1 c) Roof Plant

Heritage Council Comment 1 c)

Figure 20: Roof plan showing proposed and existing plant platforms

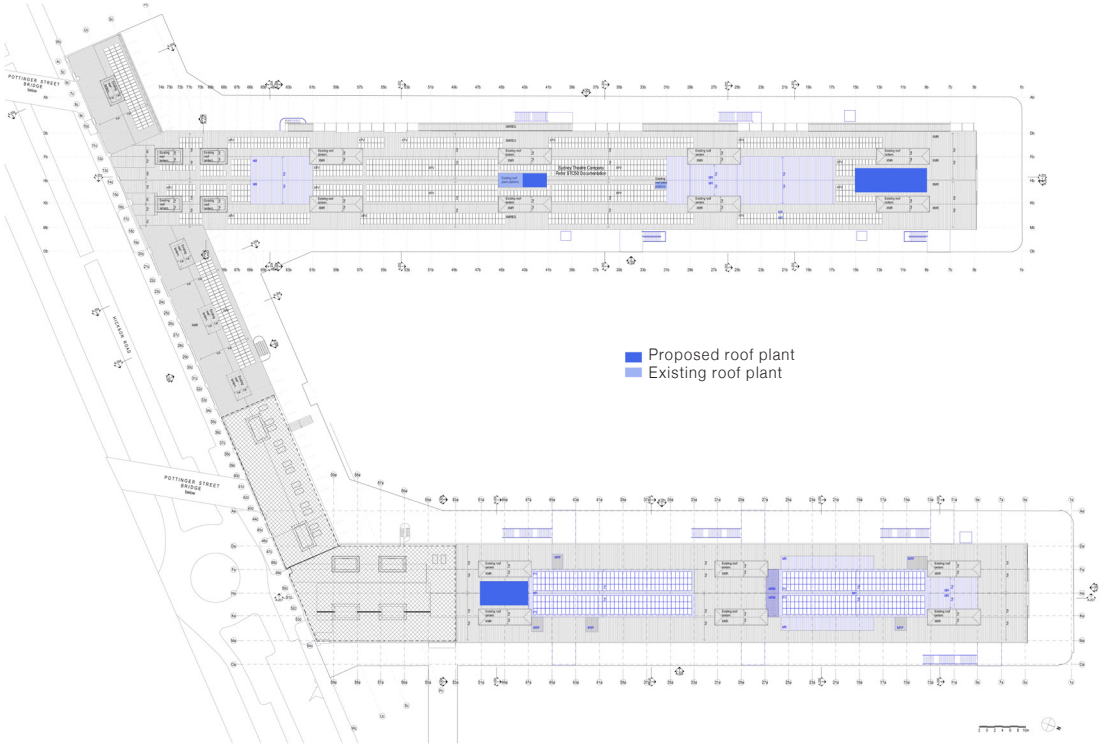
It is unclear if the proposed roof plant will be screened, in particular on Wharf 4/5. It is recommended that plant equipment is not visible from the public domain. Further design details for plant screening must be provided to the Heritage Council for assessment prior to approval of this project..

The external roof plant is proposed to be located on simple steel framed platforms set in the valleys, between the two ridge lines, to ensure that it will not be visible from the public domain. It is not proposed to be screened.

The Visual Impact Assessment that accompanies the proposal, demonstrates that the roof plant will only be visible from above – from the Harbour Bridge and higher areas of Millers Point – as per the existing roof plant on Wharf 4/5, and will not compromise appreciation of the heritage significance of the place. Oblique views will not be possible, therefore screening would not prevent views from these angles.
